**LEESBURG BOARD OF ARCHITECTURAL REVIEW
STAFF REPORT**

SPECIAL PUBLIC HEARING AND WORK SESSION FOR COURTHOUSE SQUARE PROJECT: 5 SEPTEMBER 2012

BAR Case No. TLHP-2012-0040 Courthouse Square: Commercial Mixed-use Building on Loudoun Times Mirror property. Report #1 was June 4, 2012, Report #2 was June 27, 2012, Report #3 was July 11, 2012, Report #4 was July 25, 2012 and Report #5 was August 8, 2012.

This is Report #6 – second overall review of all submissions

Figure 1 - Rendering from submission by DBI Architects of Nichiha cement fiber board panels 18" x 72" horizontal with reveals and no lapping. This rendering shows no vertical seams which will be visible as can be seen on the following pages of actual photographs or the product in use.

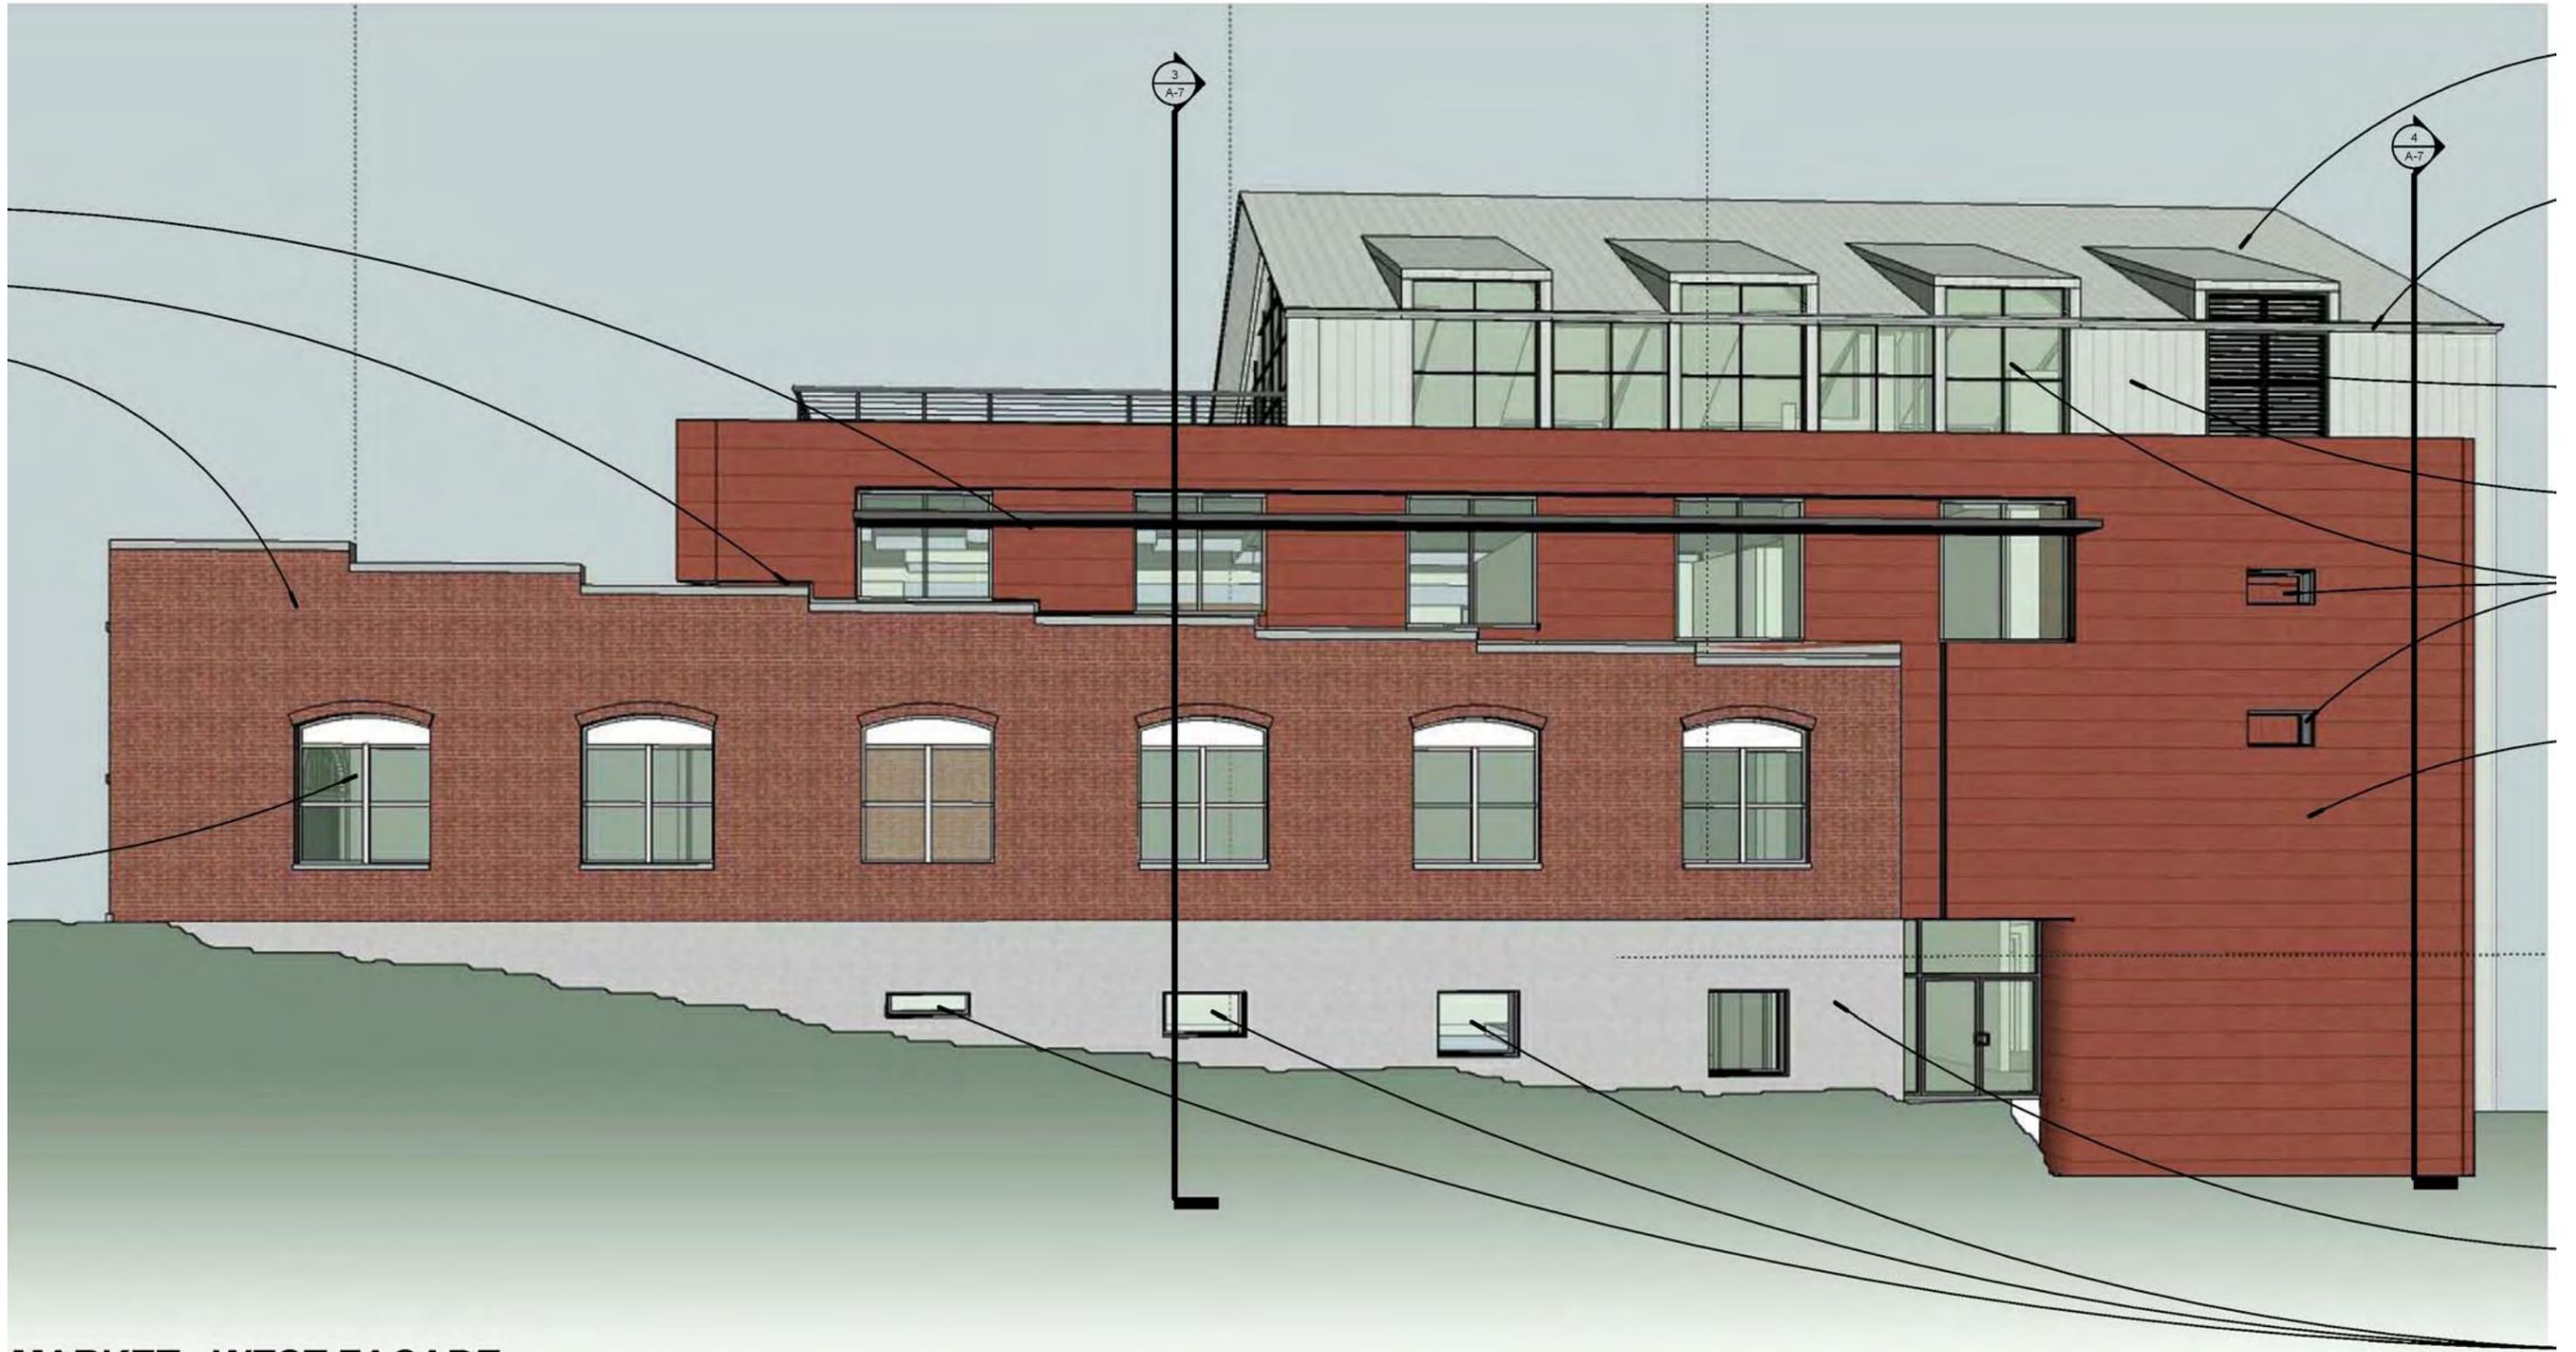
However, the *second floor* siding, which has been discussed thoroughly by the BAR at previous meetings, is in question. It is not clear how the proportions of the 18 inch tall and 6 foot long panels will look against the scale of the traditional sized bricks on the Loudoun Times Mirror building. Staff is concerned that this siding treatment is not compatible with the historic LTM building. This is important because the LTM building is a contributing structure on one of the most historically intact and important streets in the National Register of Historic Places District in Leesburg.

The illustrations provided by the architect show Nichiha cement fiber board panels and what they will look like on the addition above the Loudoun Times Mirror with photographic examples of the product on built structures (Figure 1, 2, 3). Figure 4 - an alteration of Figure 1 - was created by staff to more clearly show the siding pattern that will be created by the 18 inch by 6 foot long panels as they will be situated adjacent to the historic brick pattern of the LTM building.

Staff has suggested to the applicant that the siding pattern that was originally submitted (Figure 7) would be preferable to that which is currently being proposed (see Figure 4.) Alternately, the siding pattern that is shown on Figure 5 – the vertical siding - would also be preferable to the current proposal. A photograph has been provided with these illustrative to show the Loudoun Times Mirror building adjacent to the building to the west. Both buildings are featured with the traditional horizontal wood siding typically found in Leesburg.

Note that the applicant has not agreed to either of these suggestions. Instead they will be submitting altered rendering for the BAR at the September 5 meeting which they believe will better illustrate the 18 inch, 6 foot long panes. The applicant has stated that a non-traditional type of siding can be appropriate when there is a limited amount of siding on adjacent properties. However, staff finds that this position is not supported by the Old and Historic District Guidelines which state that wood siding is appropriate. Further, if a non-traditional material is used it must convey the appearance of the district's historic wood siding. The Nichiha 18" x 6' horizontal panels do not meet this intent and it is staff's assessment that the use of Nichiha panels would not subordinate the new construction to the smaller dimensions of the LTM building.

Staff finds that the proportions on the *original submission* (Figure 7) or the horizontal application of the same size Hardie siding can be approved as fitting the intent of the Leesburg Old and Historic District Guidelines.

- The siding on the second floor of the addition to the Loudoun Times Mirror is approved to be the proposed color but in the original submission of James Hardie fiber cement board siding in smooth finish with no grain.
